ECE/TRANS/WP.29/GRE/2009/6 16 January 2009

REGULATION No. 48 (Installation of lighting and light-signalling devices)

Clarifications on installation requirements

Proposal for Supplement 4 to the 04 series of amendments to Regulation No. 48

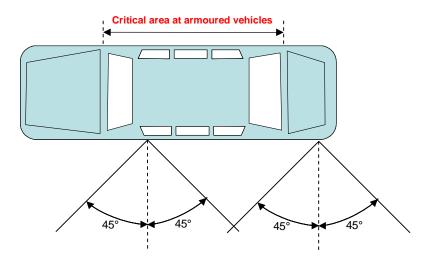
Total vehicle length < 6 m: no side-marker lamp and no side retro reflector required

**Actual Requirement:** Vehicle length > 6 m, visibility of SML

**Proposal:** Vehicle length > 6 m, visibility of SML
